# TOWN OF PLAINFIELD DESIGN REVIEW COMMITTEE REPORT

REQUESTED ACTIONS: Development Plan Approval for a Drive-Through Coffee Restaurant

LOCATION: 1101 W Main St

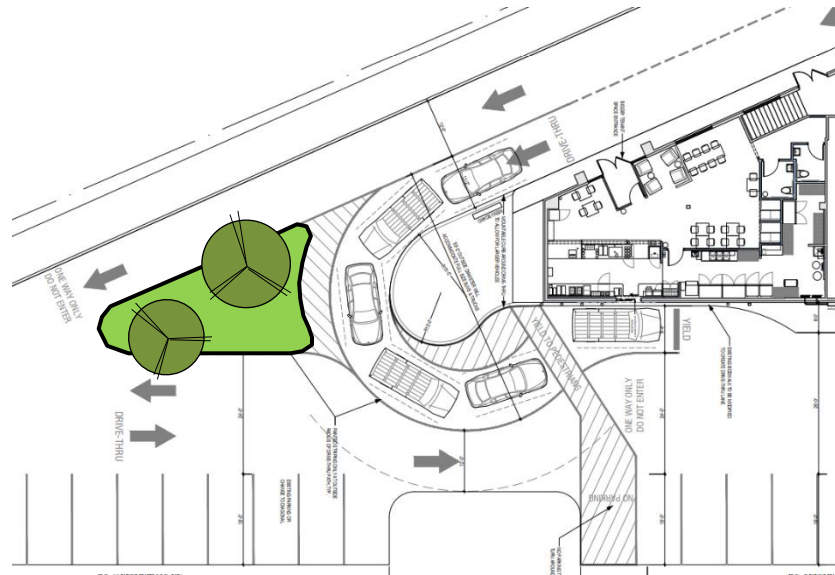
1. Adding a drive-through facility to this site will impact vehicular circulation. The applicant has proposed using pavement markings to direct and control the flow of traffic around the building, which would be limited to one-way in certain locations. Staff recommended that the painted island to the west of the building be replaced with a rolled-curb island which could including landscaping. This improvement would physically limit the flow of traffic on the site and decrease the likelihood of eastbound travel on the north side of the building. Adding landscaping would help soften the visual impact of the drive-through stacking area.

Similarly, there would not be any physical barrier preventing westbound traffic from crossing the drive-through stacking area on the south side of the building. The transition from two-way to one-way to two-way travel could be problematic. Adding physical definition to the drive-through could be more effective at controlling and restricting traffic flow.

*DP-12-001 Landscape Plan*

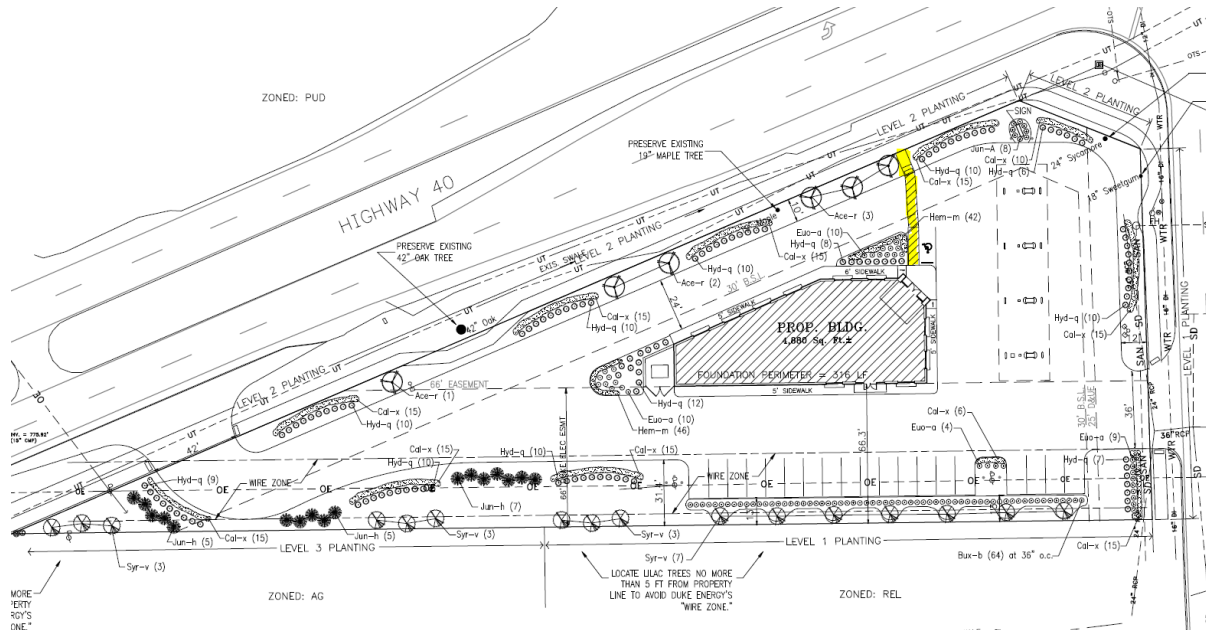
2. The original development plan showed a pedestrian connection at the northeast corner of the building which was not installed. It should be noted that at the time of approval the ordinance also required a connection with Moon Rd. which was waived by the Plan Commission. The applicant has indicated that the project will comply with the ordinance but at this time staff does not have details on how that will be accomplished.

3. As part of the request for a Development Plan Amendment an updated landscape plan reflecting the existing landscaping should be submitted for review.
4. The proposed dumpster enclosure would be located a considerable distance from the building and the doors would be facing Main St. Given the propensity for enclosure doors to remain open or be “pinned” behind the dumpster, is this a desirable location and orientation?
